ROCKY MOUNTAIN ARSENAL

FINAL
SANITARY SEWER REMEDIATION
INTERIM RESPONSE ACTION
ALTERNATIVES ASSESSMENT
VERSION 3.2

September 1988
Contract No. DAAK11-84-D-0017

RESPONSES TO COMMENTS OF
COLORADO DEPARTMENT OF HEALTH
SANITARY SEWER REMEDIATION
DRAFT FINAL INTERIM RESPONSE ACTION
ALTERNATIVES ASSESSMENT

PLATE I

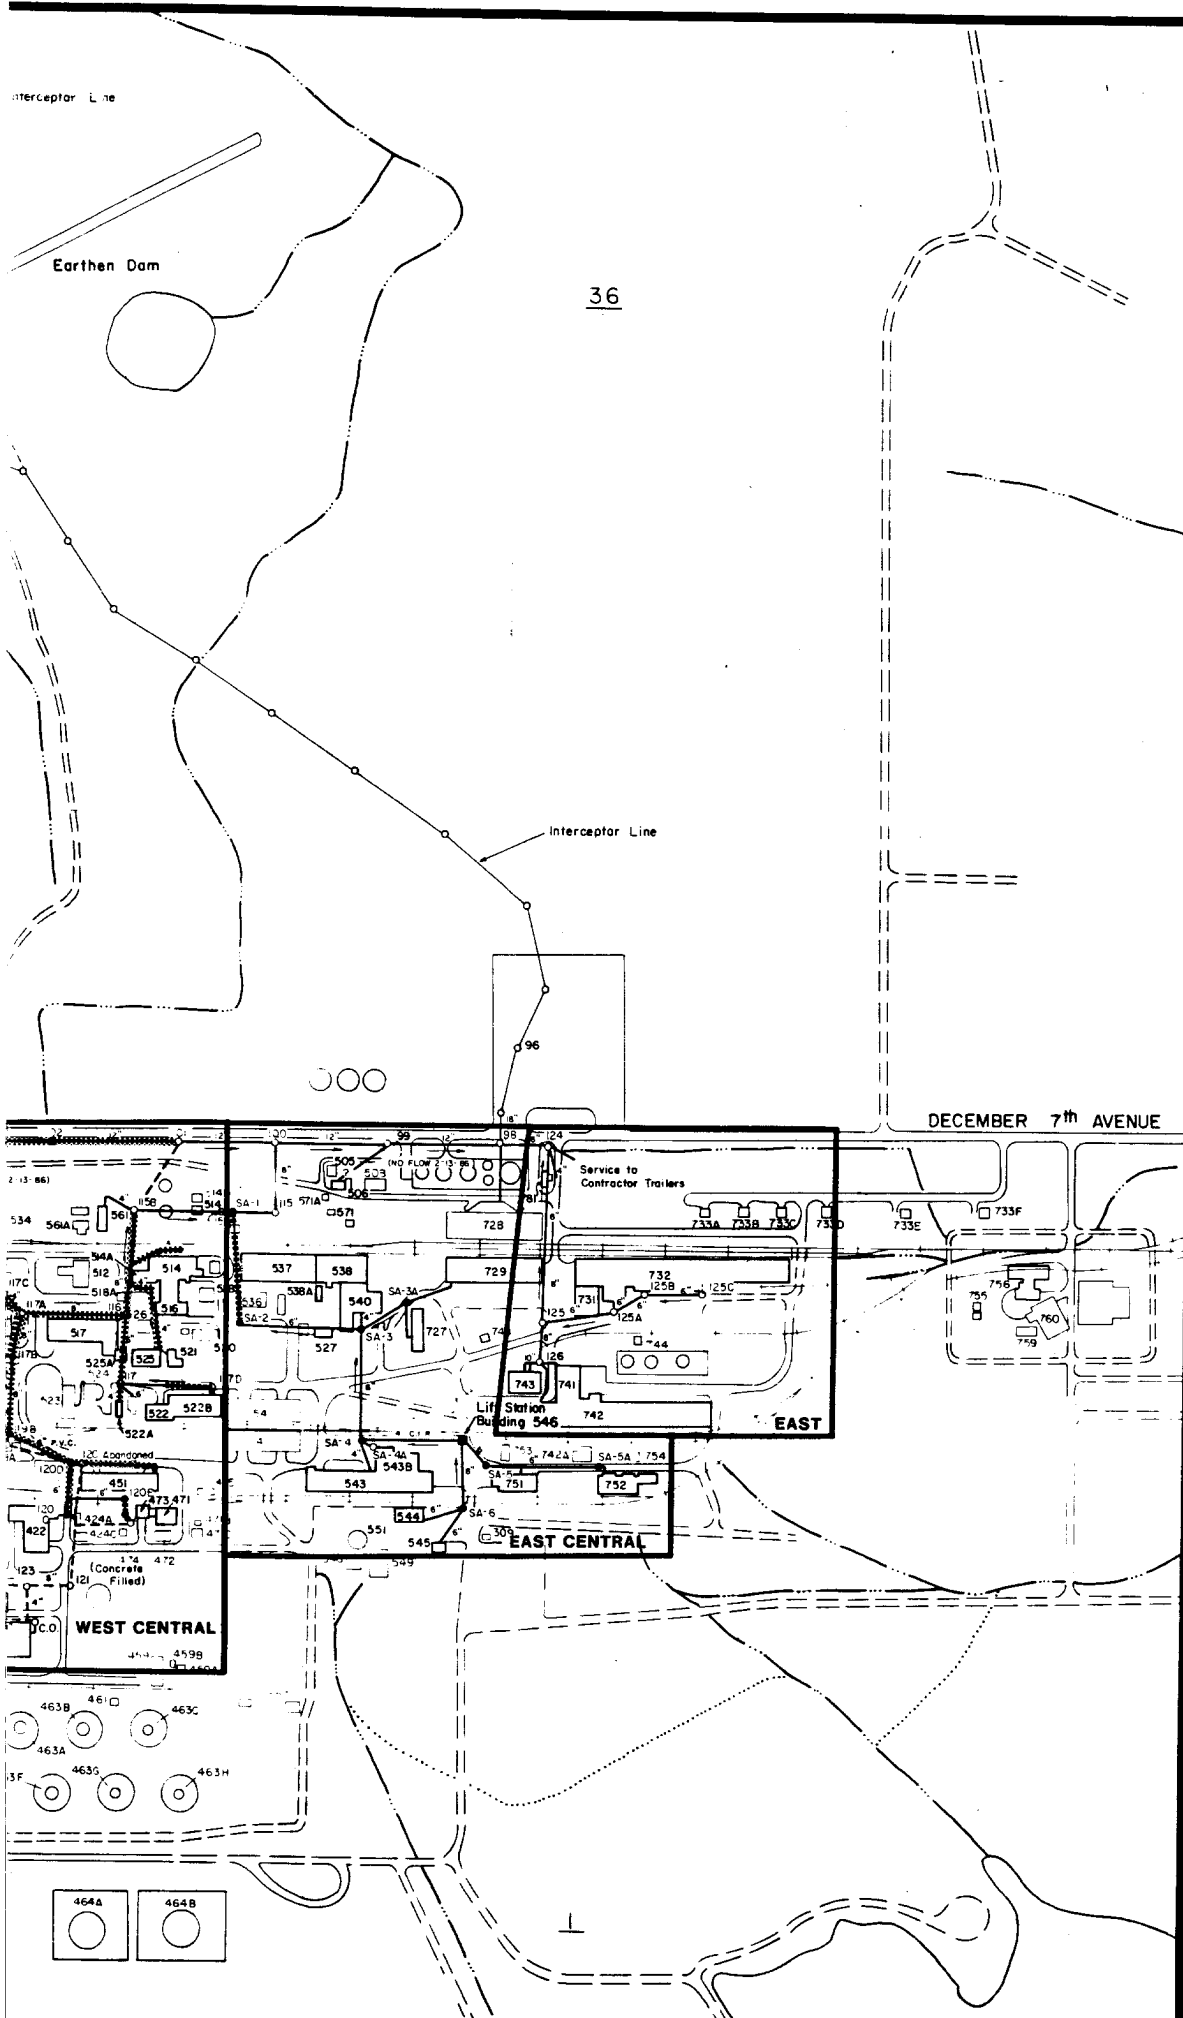
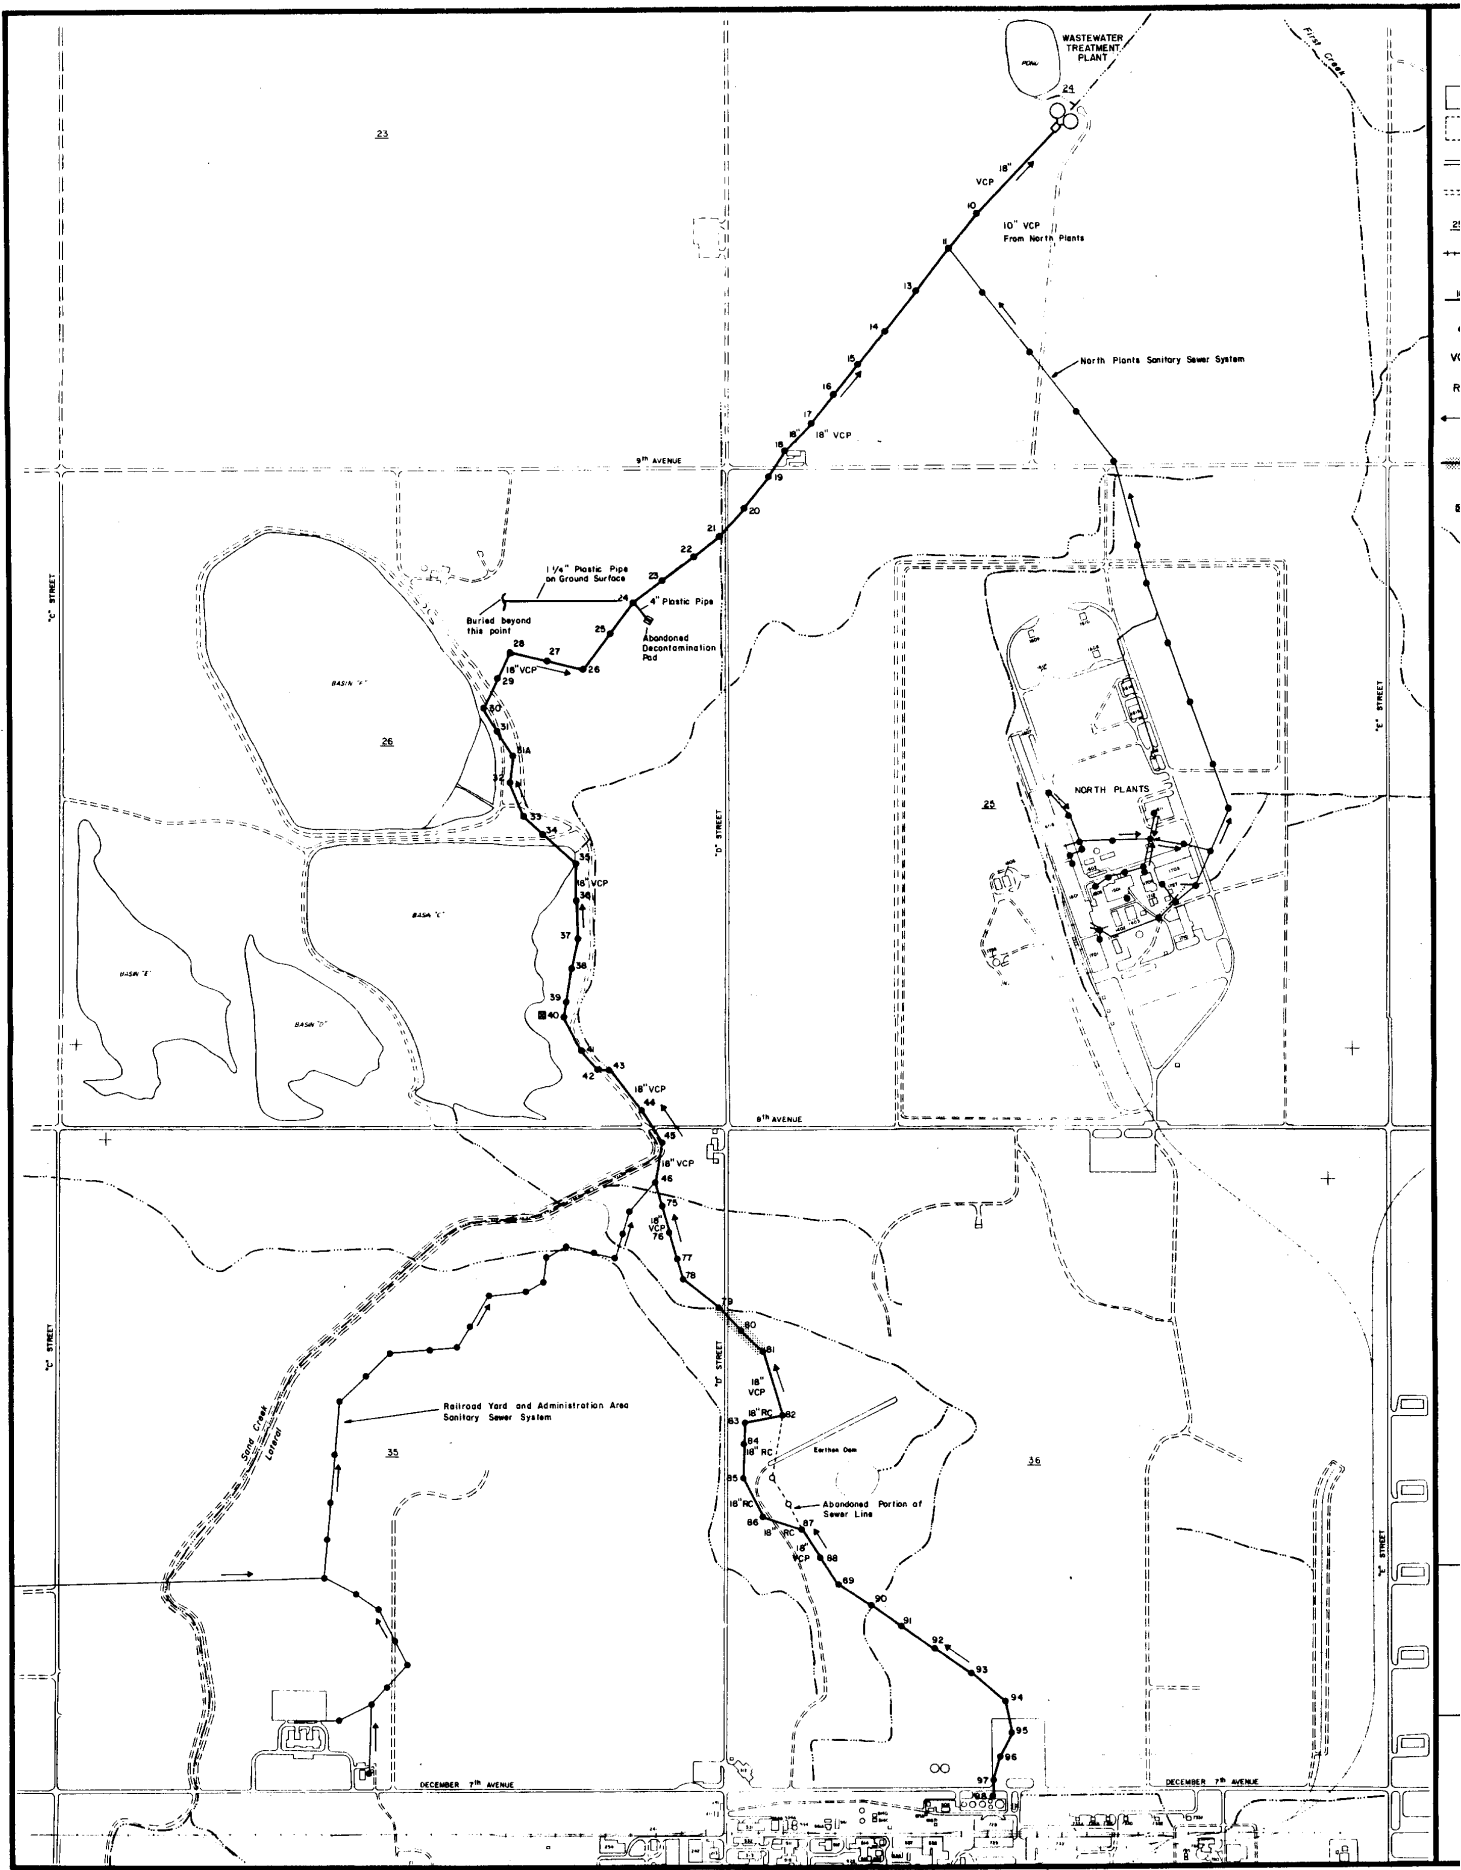
Comment 8:

Plate 1: The plate has been revised to correspond to the text on page 5, where it is stated that Black and Veatch noted heavy infiltration between Manholes 101 and 103. Additional infiltration may be taking place, but this is the only section for which supporting documentation has been found.
